Streets for People – Grey Street, Gisborne
Concept Stage Safe System Audit Report
Prepared for Gisborne District Council

REVISION 0- OCTOBER 2023

Figure 5.3-1 – Proposed tree planters in front of the skate park

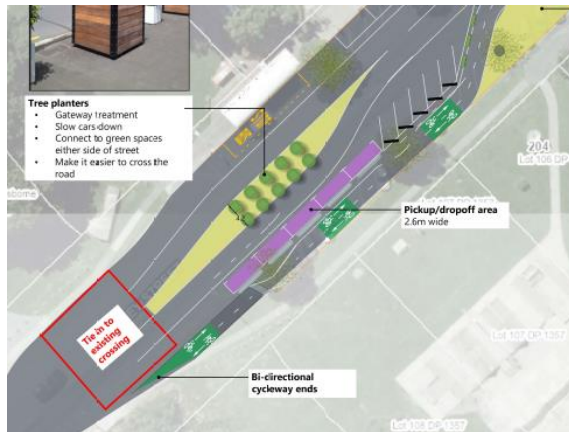
Tree planters are proposed to be installed at the designed central medians in front of the skate park and at the Grey Street/Kahutia Street intersection. Visibility restrictions are expected to be generated by the proposed planters, likely generating the following issues:

- As observed during the site visit, pedestrians cross the road east to west (and vice-versa) in front of the skate park to access the public toilets and bus stop. The raised zebra crossing is provided south of this point; however, pedestrians are inclined to use the shortest path (i.e., desire line), which explains the observed crossing behaviour. The tree planters illustrated on the plans are relatively high. When pedestrians are crossing the road on the north side of the proposed planters, the intervisibility between these users and northbound vehicles is expected to be restricted. When crossing the road on the south side of the planters, conflicts between pedestrians and southbound vehicles could arise. Note that the conflict risk is higher if the pedestrians are children due to their low height, and a high children presence is noted at this location;

- Similarly, at the proposed courtesy crossing through Grey Street, pedestrians crossing the road east to west could not be visible to northbound vehicles, establishing the risk of conflicts between them.

1. Consider an alternative treatment on the central median that does not create visibility issues (for instance, low-height vegetation); and
2. Consider providing a formal pedestrian crossing between the public toilet/bus stop/i-Site and the skate park.

Design Team Response: (1) We've amended the median planting design, now proposing low-level planters in both medians. The taller planters will be 600mm high, while the shorter planters will be 400mm high and be prioritised next to the proposed crossing island and where pedestrians may walk past them to cross casually. 600mm high planters will be 'boxed in' by shorter planters such that there will be distance between those and pedestrians to increase sightlines (2) Unfortunately an additional crossing is considered out of scope of this trial project, but this recommendation will be passed on for the design of any permanent solution to follow the trial. In the interim, casual crossing will be made safer by reduced vehicle movements, speeds, crossing distances and hopefully reduced vehicle volumes too.

Safety Engineer: I agree that suitable sightlines need to be provided appropriate to vehicle speeds. Ideally, vehicle speeds should be moderated and below 30 kph.. The width and shape of the island could also be designed to help provide suitable sightlines. Landscaping should be designed to suit sightlines also. Landscaping will also need to be managed, installed and maintained, to avoid impeding sight lines. It is noted that further consideration will be given to formal crossing facilities after the trial. Pedestrians should be encouraged to cross where it is safe to do so which could be through the provision of formal facilities but also through other measures such as breaks in the parking, access points and coloured surfacing.

Client Decision: Plants will be maintained by our contractor throughout the trial to ensure they cause no sight issues.

Action Taken: Low planter boxes to be installed with low growing plants that will not cause sight issues. Contractor has been engaged to maintain the planter boxes for the duration of the trial.

Figure 5.3-4 – Raised vehicle crossings along Grey Street

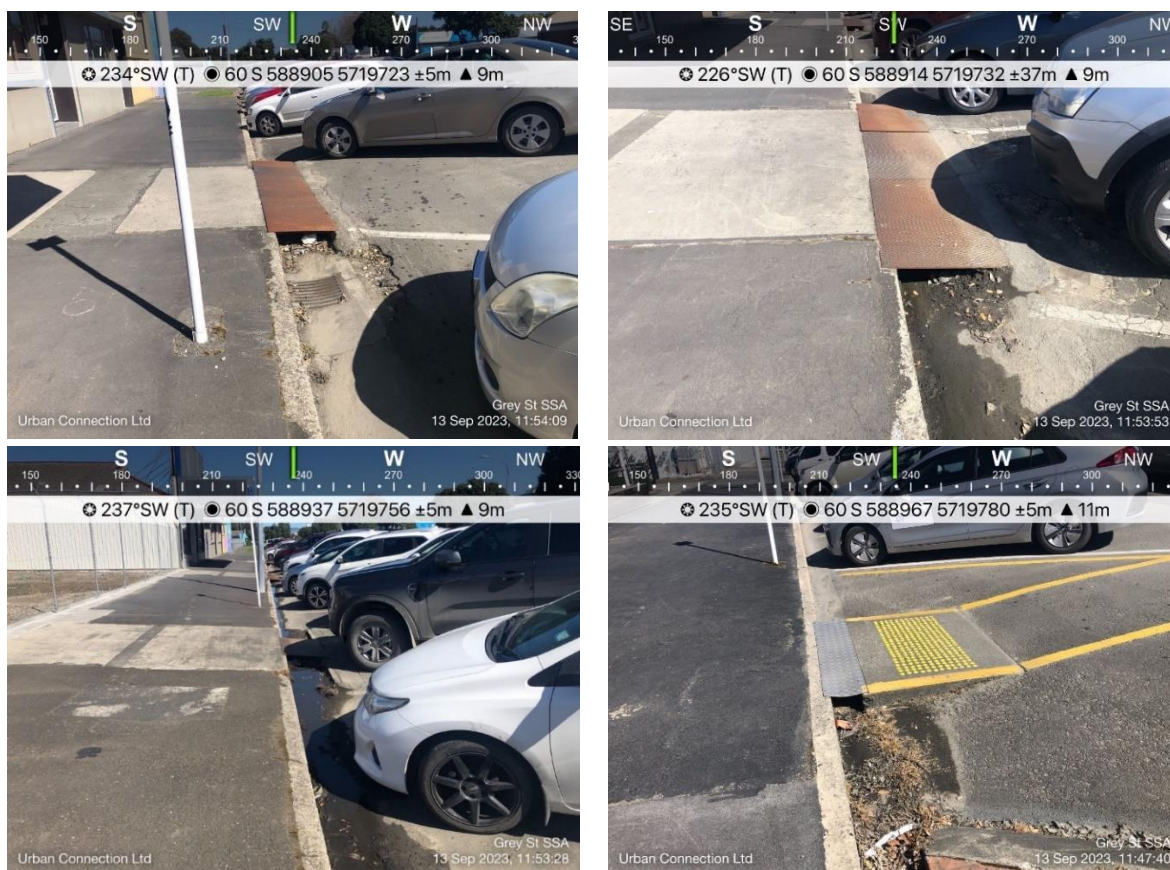
Furthermore, several vehicle crossings are located throughout this section of Grey Street. Due to the steep crossfall, vehicle crossings are raised on the road to enable appropriate vehicle access. As is, the vehicle crossings would both reduce the effective width of the southbound cycle lane and be a hazard for cyclists due to the level difference. Once again, this establishes a potential risk for cyclists to lose their balance and fall, especially in dark conditions. Note that the design does not provide details of how the existing carriageway is to be treated to accommodate the cycleway, which is expected for the concept stage of the project.

Some catch pits are also located throughout the section. In this case, it is important to confirm that these are cycle-friendly to remove the risk of unseating/catching a cyclist's wheel, which could result in issues for cyclists.

1. *Provide details of how the existing carriageway and vehicle crossings are to be treated to accommodate the proposed cycleway;*
2. *Provide a maximum crossfall of 3% throughout the cycleway;*
3. *Remove the on-road level difference generated by the vehicle crossings or offset the cycleway from the vehicle crossings; and*
4. *Provide cycle-friendly catchpit grates.*

Probability Rating:	Severity Outcome Rating:
<i>The probability of a crash is Likely</i>	<i>Crashes are likely to be Serious</i>
<i>Design Team Response:</i> Crossfalls have now been measured throughout the project extents. It has been confirmed that some sections are above desirable grades for a cycleway. Although remediation of carriageway grading is generally considered beyond the scope of a project of this nature, we have been investigating an option to remediate the steepest sections, and are awaiting pricing information to confirm our options	
<i>Safety Engineer:</i> Two wheeled cyclist are less susceptible to transverse grades. However, the facility should cater for trikes and mobility users which require modest transverse grades as suggested. Suitable transitions over or around vehicle crossings should be provided. Cycle friendly sump grates should be provided.	
<i>Client Decision:</i> After further pricing information has been received, the decision to not level the cross fall was made due to funding. Users will be monitored, and this is something we will look to remediate if there is a permanent stage.

Figure 5.3-13 – Missing tactile pavers at crossing points across Childers Rd (east of Grey St)

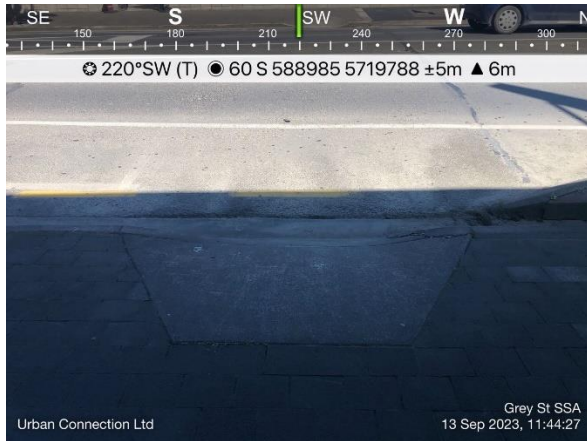
There are flush pedestrian crossings, courtesy crossings, and a raised table dual crossing proposed across Grey Street, Kahutia Street, and Childers Road. As shown in Figure 5.3-12 to Figure 5.3-15, Tactile Ground Surface Indicators (TGSIs), both directional and warning tactiles, are missing at several crossing points on Grey Street and side roads throughout the section. It is noted that the proposed designs do not have tactile pavers shown on them.

Probability Rating:	Severity Outcome Rating:
The probability of a crash is Very Unlikely	Crashes are likely to be Serious
Design Team Response: Warning tactiles will be added to all crossings affected by, or proposed by this project . These are proposed to be adhesive, given the trial nature of this project. These are included in v1.3 of the plans. Unfortunately crossings which are not affected by this project are considered to be out of scope for addition of tactiles, given cost constraints.	
Safety Engineer: The designer advises that TGSIs are to be provided for crossings within / affected by the project. I support the suggestion of reviewing other related crossings / facilities to provide connected and cohesive guidance for visually impaired users, albeit this may occur outside the project.	
Client Decision: Tactiles to be installed as per the design recommendation.	
Action Taken: Tactiles to be installed as per the design recommendation.

Figure 5.3-20 – Merger of the cycleway and the footpath (extracted from the design)

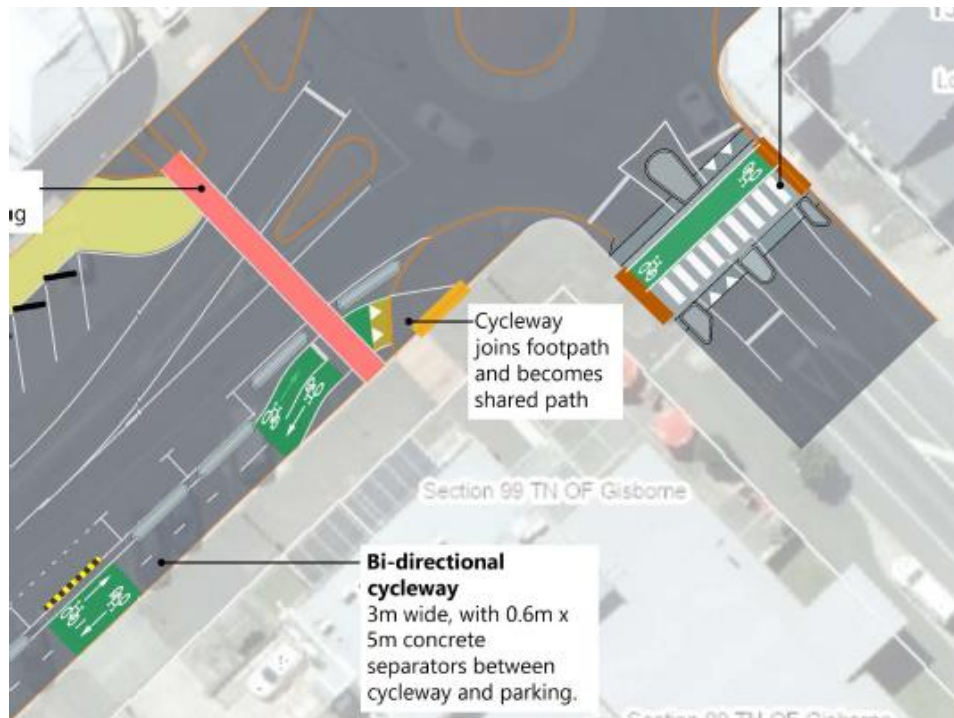
Prominent crash type		▪ Collision between cyclists/vehicles and pedestrians
Probability	Likely	▪ High turning volumes ▪ Relatively high crossing demand
Severity	Minor	▪ Impact speed less than 30km/h threshold speed

Probability Rating:	Severity Outcome Rating:
The probability of a crash is Likely	Crashes are likely to be Minor
Design Team Response: Various modifications are included in plan set version 1.3 to address these concerns . We consider that beginning a shared path south of the Grey Street courtesy crossing would lead to further hazard, as cyclists and crossing pedestrians would still cross each others paths, however within a smaller space, plus with a greater distance of shared path, which increases danger and conflict for all users. We now propose to extend the separated, dedicated cycleway and dedicated footpath to extend as far as the dual crossing over Childers Road, such that conflict between users is reduced. To increase legibility and consistency of RoW, we have removed the limit lines from the cycleway at this crossing, such that the pedestrian courtesy crossing legally gives way to the cycleway just as it gives way to the carriageway.

Figure 5.3-25 – Proposed parking spaces (extracted from the design)

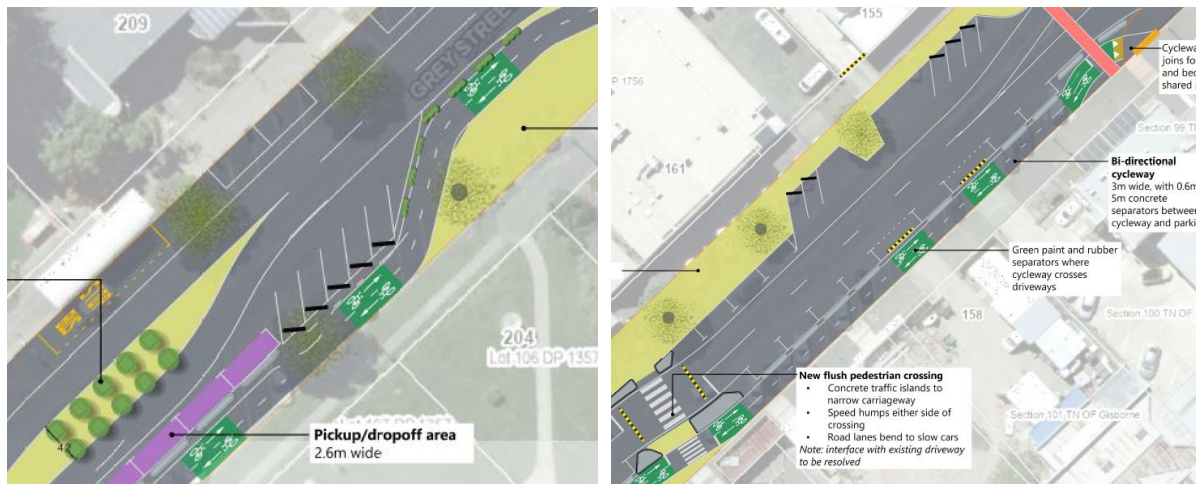
Existing angle car parking spaces are proposed to be removed throughout the section, being converted to new angle or parallel car parking spaces (as shown in Figure 5.3-25). The dimensions of both the parallel and angle car parking spaces are missing from the proposed design plans; hence, the auditors are unable to assess whether the proposed parking spaces are able to safely serve their intended purpose.

Parallel parking is also proposed throughout the section, mostly immediately adjacent to the traffic lane. The dimensions of the parking spaces are typically not provided on the plans. It is important to ensure that suitable space length and width are provided in accordance with AS/NZS 2890.1:2004, depending on the width of the adjacent traffic lanes. This is deemed required for easing of manoeuvring into the parking spaces. A difficult parking manoeuvre could generate queueing that could lead to rear-end crashes. Additionally, it could generate damage-related crashes with parked vehicles.

1. Provide dimensions of the proposed car parking spaces, including the reversing aisle; and
2. Ensure parking spaces are designed in accordance with ASNZS 2890.1-2004.

Design Team Response: Dimensions have been added to planset version 1.3. Proposed angle parking is designed to meet the existing precedent on Grey Street, with manoeuvring aisles being the same as those for existing parks. Long sight lines have been maintained between angle parking and adjacent carriageway lanes, while the design also plans to reduce traffic speeds. Line-marking plans in version 1.3 include full dimensioning for the proposed angle car parks

Figure 5.3-33 – Entrance to tyre shop across the footpath

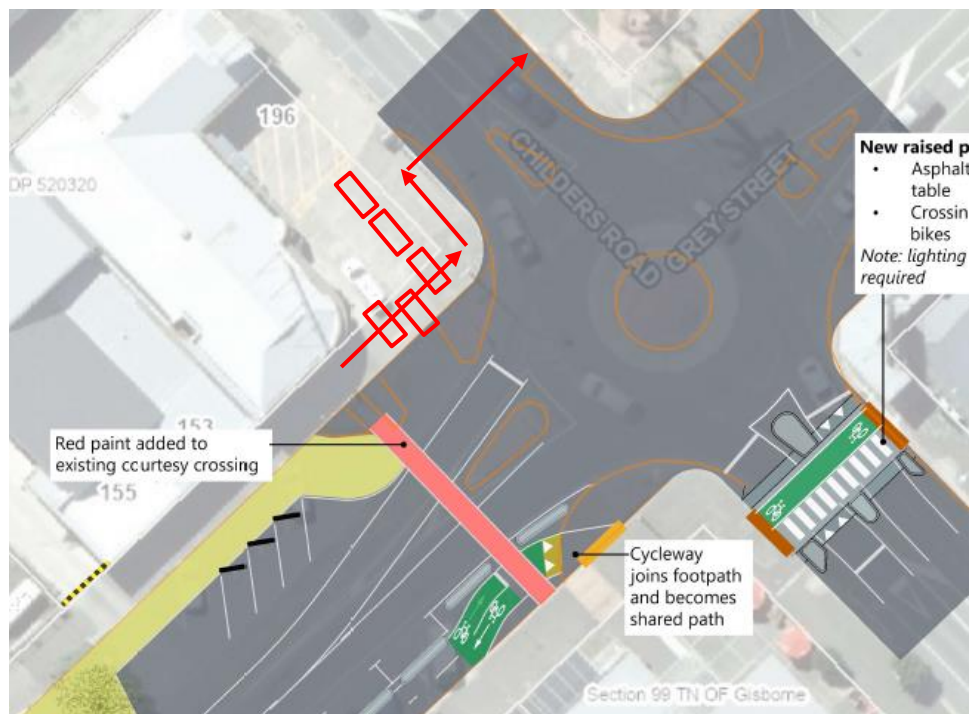
Prominent crash type		▪ Vehicle against pedestrian ▪ Side-impact crash at the roundabout
Probability	Unlikely	▪ Low manoeuvring and approaching speeds
Severity	Minor	▪ Impact speeds are likely to be less than 30 km/h

Probability Rating:	Severity Outcome Rating:
<i>The probability of a crash is Unlikely</i>	<i>Crashes are likely to be Minor</i>
Design Team Response: We suggest that GDC discuss this with the adjacent business owner as recommended. We don't support signage and markings at this stage, because: 1) Footpath parking is always illegal. adding additional signage and markings to this location may imply to others that such parking is acceptable at other locations on footpaths, so should be carefully considered 2) Currently any changes to this footpath are out of our scope for this trial project due to budget limitations	
Safety Engineer: It is agreed that it is undesirable to have traffic queued on the footpath. It is also agreed that this is best managed by the Council, via consenting and / or enforcement, and that additional signs and / or markings are best avoided within the road corridor. The infrastructure should be built and provided to encourage appropriate behaviour, albeit this may need to be addressed at a later stage. The footpath for example should appear continuous, rather than 'ceasing' either side of the vehicle crossing, as this would suggest and reinforce pedestrian use and rights to the footpath space. The 'entry' word painted on the footpath could imply legitimate use of the footpath by drivers thus could be removed. Providing alternative short stay parking or a loading zone in the vicinity may also help. A barrier should also be installed around the property to limit the risk of vehicles manoeuvring on or over the footpath and colliding with pedestrians. This would also help define the entry and exit points.
